Bulletin FM183

FAIRBANKS-MORSE

INSTALLATION OF MAGNETO VENT

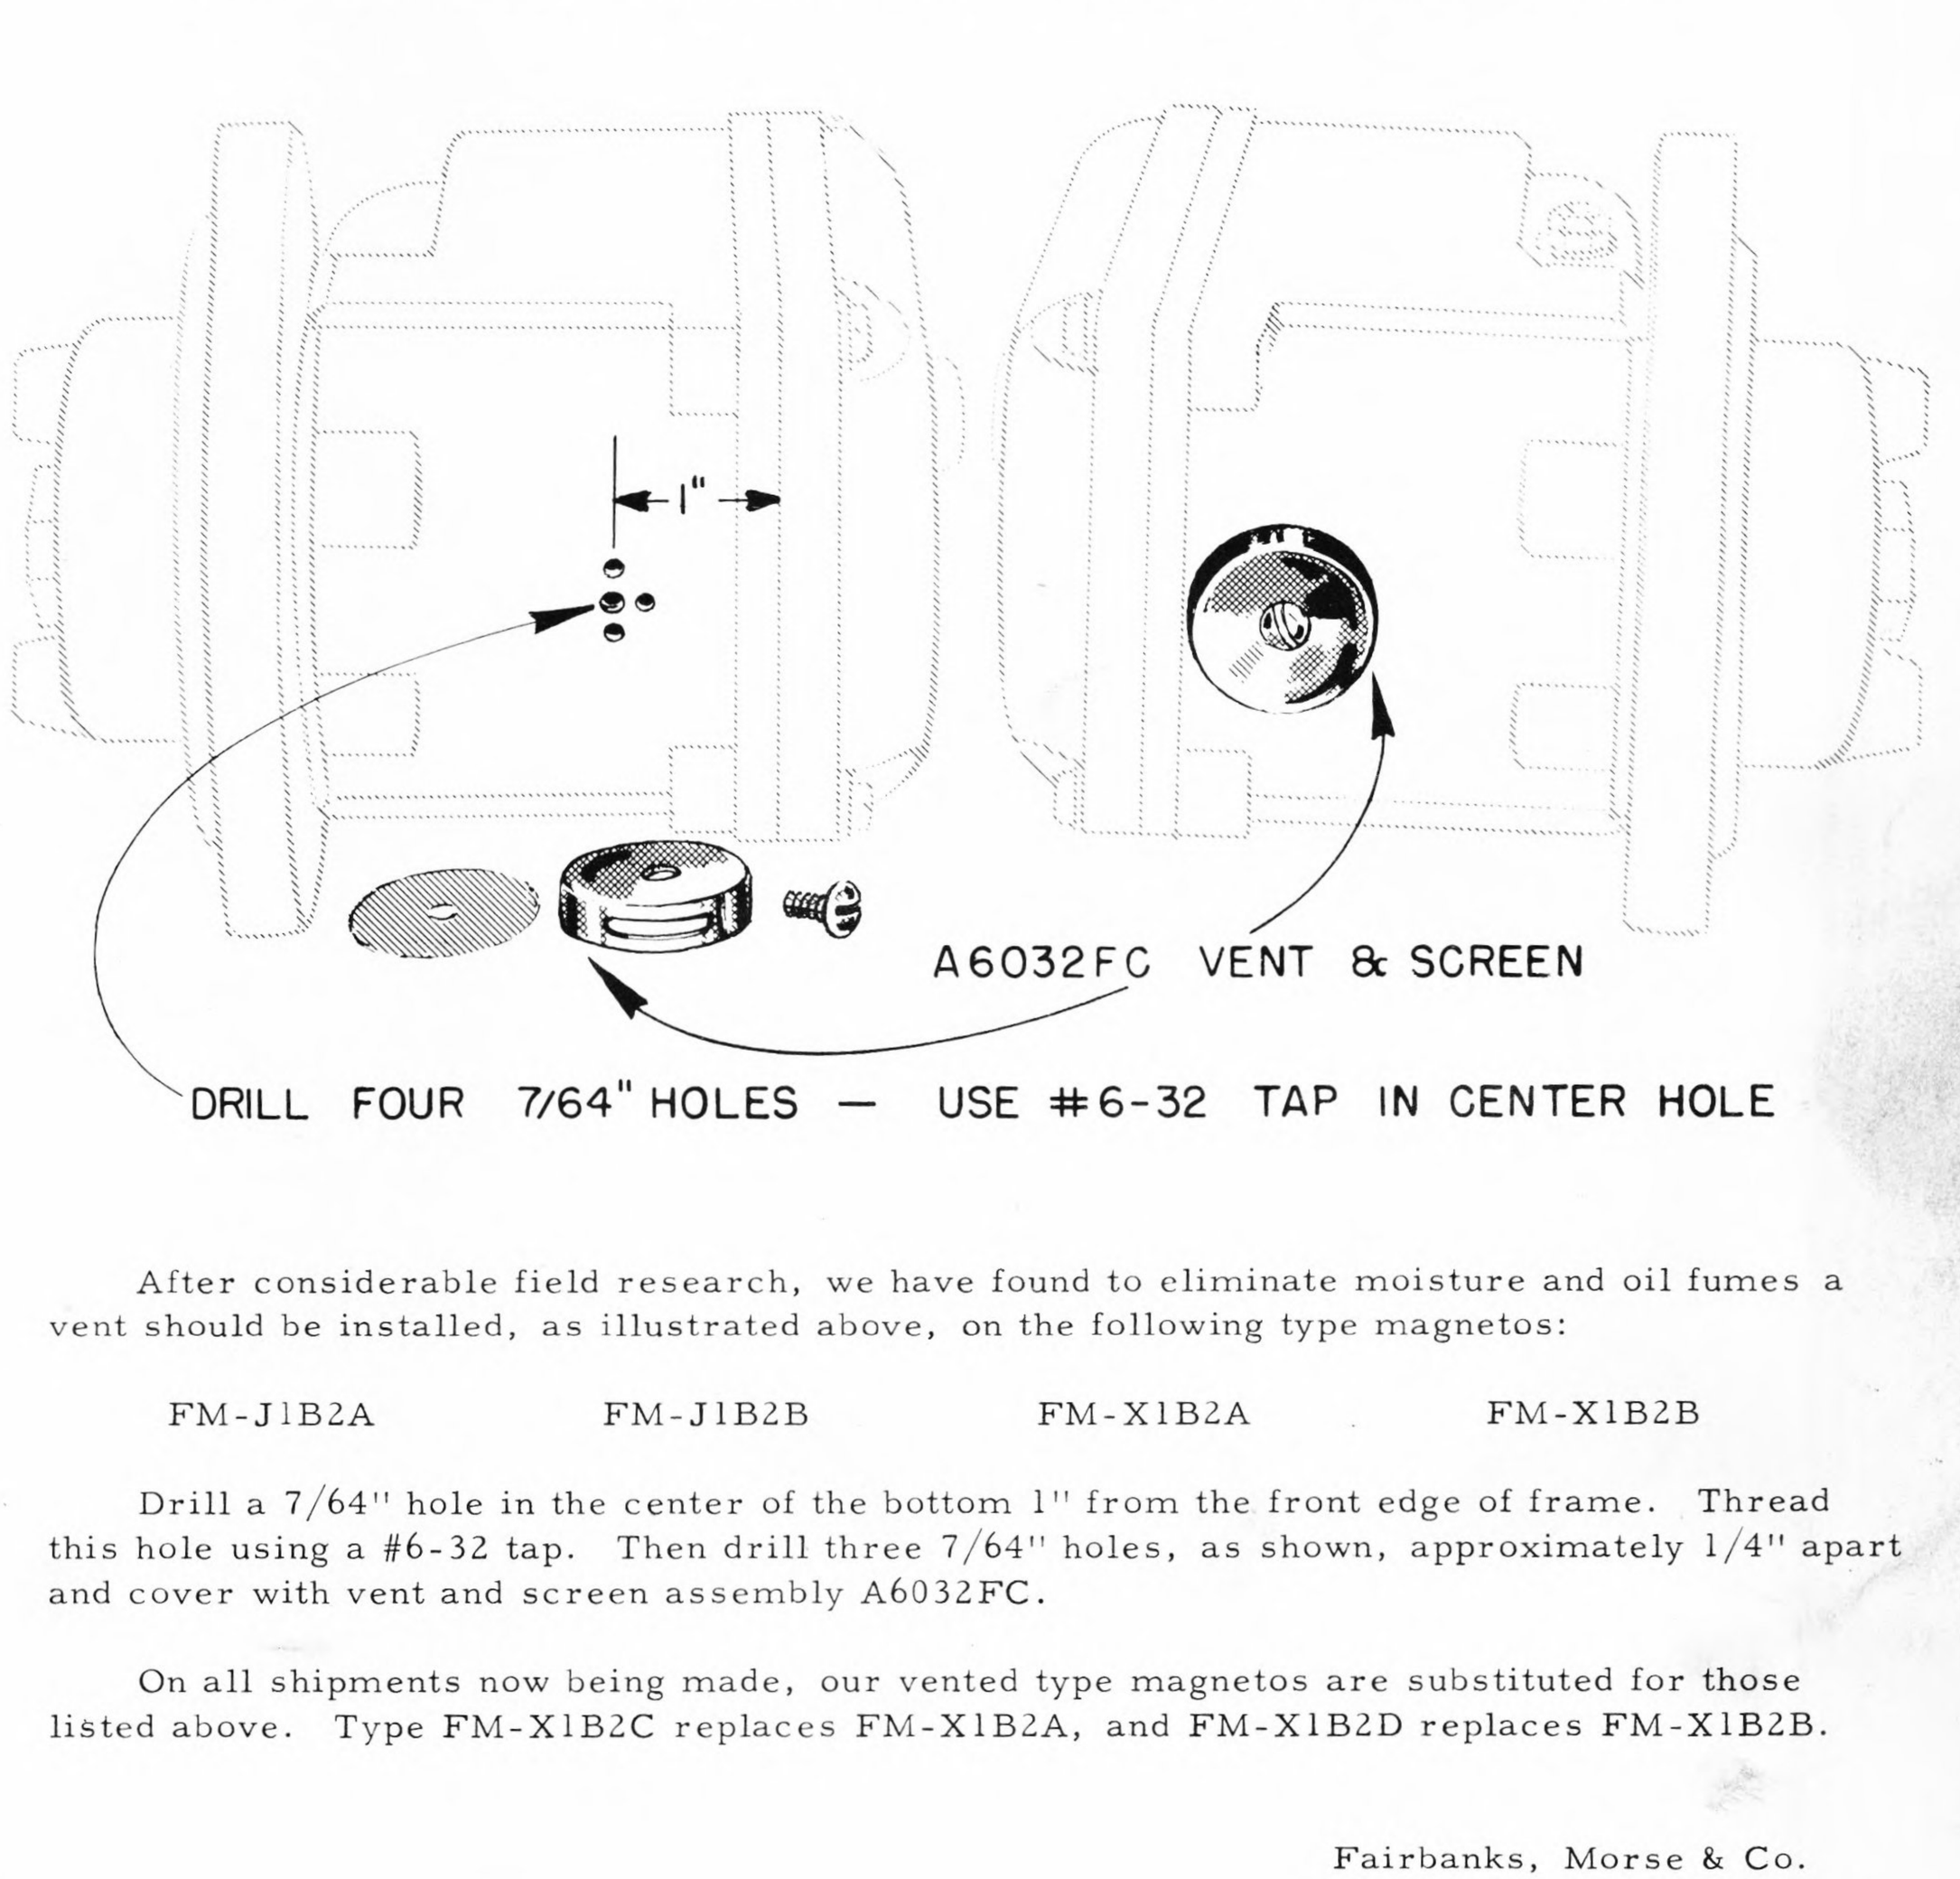
After considerable field research, we have found to eliminate moisture and oil fumes a vent should be installed, as illustrated above, on the following type magnetos:

FM-J1B2A FM-J1B2B FM-X1B2A FM-X1B2B

Drill a 7/64" hole in the center of the bottom 1" from the front edge of frame. Thread this hole using a #6-32 tap. Then drill three 7/64" holes, as shown, approximately 1/4" apart and cover with vent and screen assembly A6032FC.

On all shipments now being made, our vented type magnetos are substituted for those listed above. Type FM-X1B2C replaces FM-X1B2A, and FM-X1B2D replaces FM-X1B2B.
